Product Change Notification - SYST-04NMLU519

ERRATA - USB251xB/xBi Family Silicon Errata

USB251xB/xBi Family Silicon Errata

FIGURE 1: RC CIRCUIT DIAGRAM

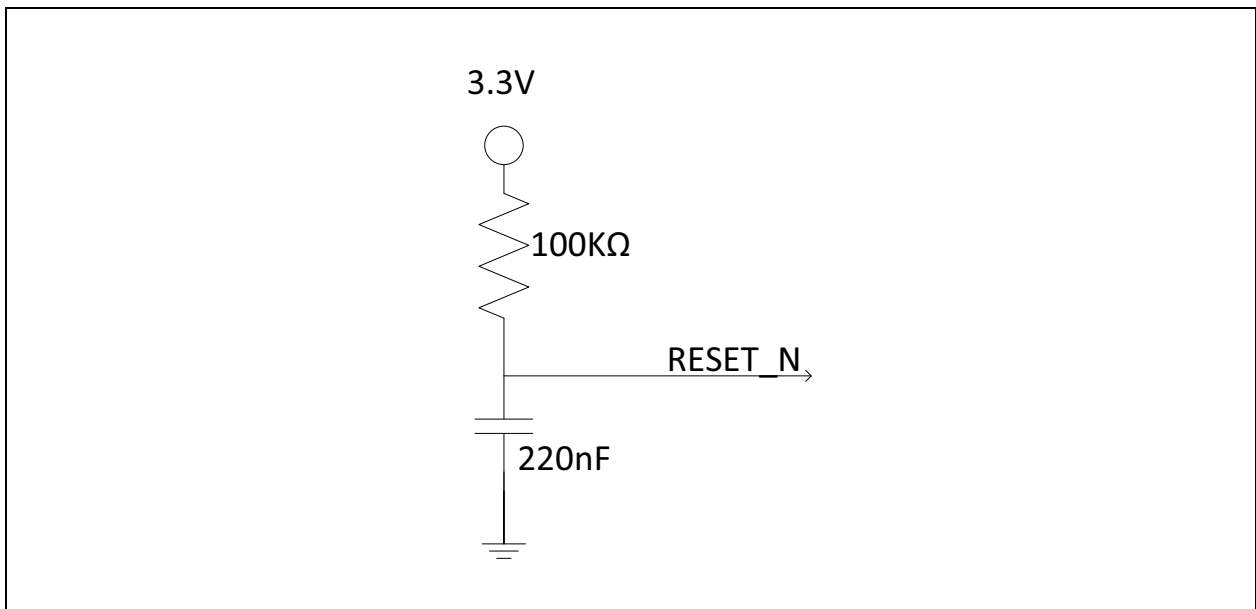
Module 3: Glitch on DP (and SD/SCL) during power-up

When the Hub is powering up, the DP pin is asserted before other internal logic has started. When the internal logic does start, it can cause a low pulse on the SMBus and DP pins.

The USB protocol can handle a glitch on DP, so no user impact on the USB lines. The SMBus glitch can impact the state machine of the SMBus Controller.

Keep the RESET_N pin low during POR to remove this glitch. Control RESET_N through a digital controller or an RC circuit by connecting a 100K Ω pull-up resistor to 3.3V and a 220nF capacitor to ground. See RC circuit diagram below.
